# Intel<sup>®</sup> Pentium<sup>®</sup> III Processor Specification Update

Release Date: March 2002

Order Number: 244453-038

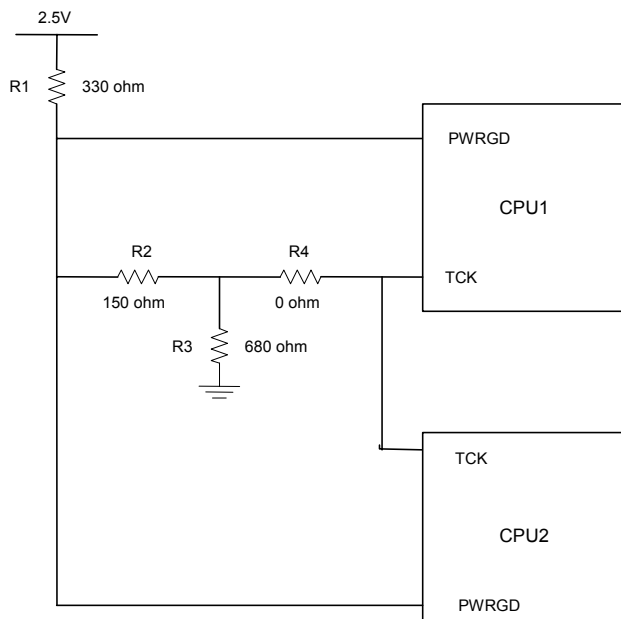
**Problem:** The internal control register bit responsible for operation of the Thermtrip circuit functionality may power up in a non-initialized state. As a result, THERMTRIP# may be incorrectly asserted during de-assertion of RESET# at nominal operating temperatures. When THERMTRIP# is asserted as a result of this erratum, the processor may shut down internally and stop execution but in few cases continue to execute.

**Implication:** This issue can lead to intermittent system power-on boot failures. The occurrence and repeatability of failures is system dependent, however all systems and processors are susceptible to failure. In addition, the processor may fail to stop execution during the event of a valid THERMTRIP# assertion resulting in the potential for permanent processor damage.

**Workaround:** To prevent the risk of power-on boot failures or catastrophic thermal failures, a platform workaround is required. The system must provide a rising edge on the TCK signal during the power-on sequence that meets all of the following requirements:

- Rising edge occurs after Vcc\_core is valid and stable
- Rising edge occurs before or at the de-assertion of RESET#
- Rising edge occurs after all Vref input signals are at valid voltage levels
- TCK input meets the Vih min and max spec as mentioned in EMTS

**Figure 1: Noise Estimation**

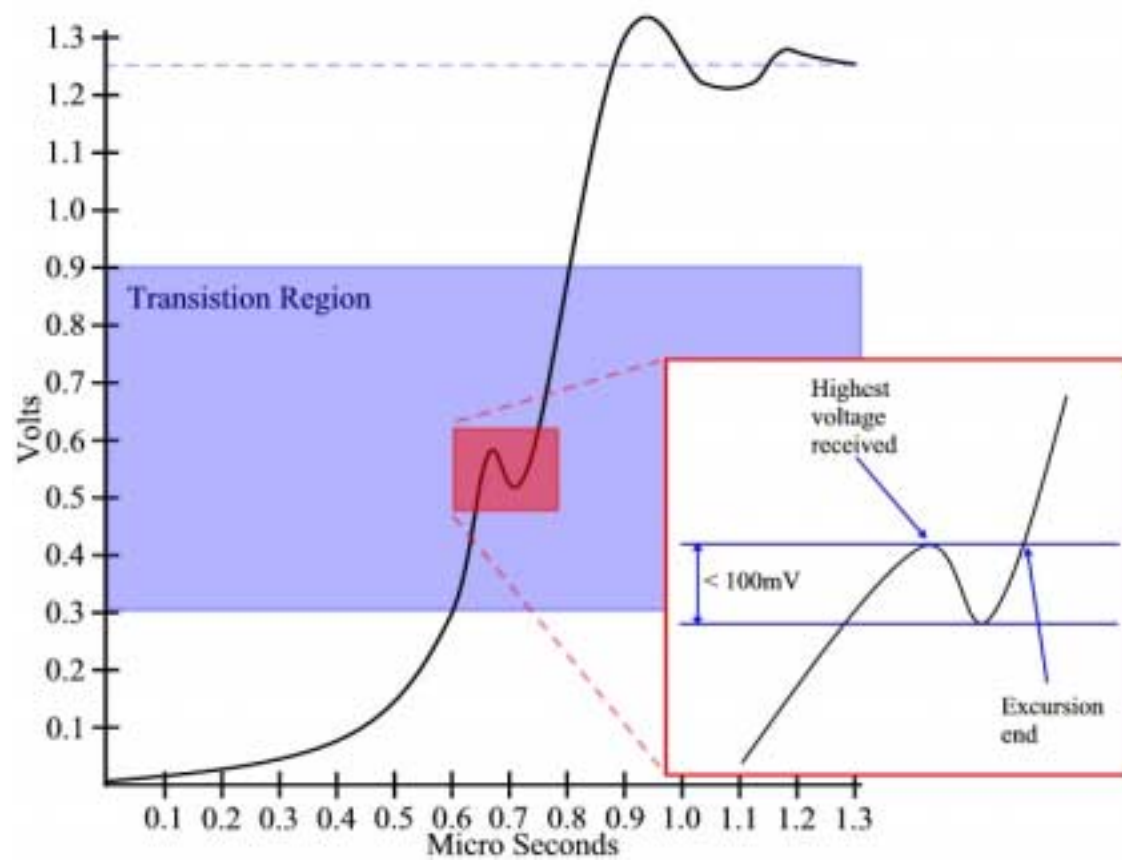
The signal quality of the VTT\_PWRGD signal is critical to the correct operation of the processor. Every effort should be made to ensure this signal is monotonic in the transition region. If noise or glitches are present on this signal, it must be kept to less than 100mV of a voltage drop from the highest voltage level received to that point. This glitch must remain less than 100mV until the excursion ends by the voltage returning to the highest voltage previously received. Please see Figure 1 for an example graph of this situation and requirements.

This change will be incorporated into the next revision of the Datasheet.
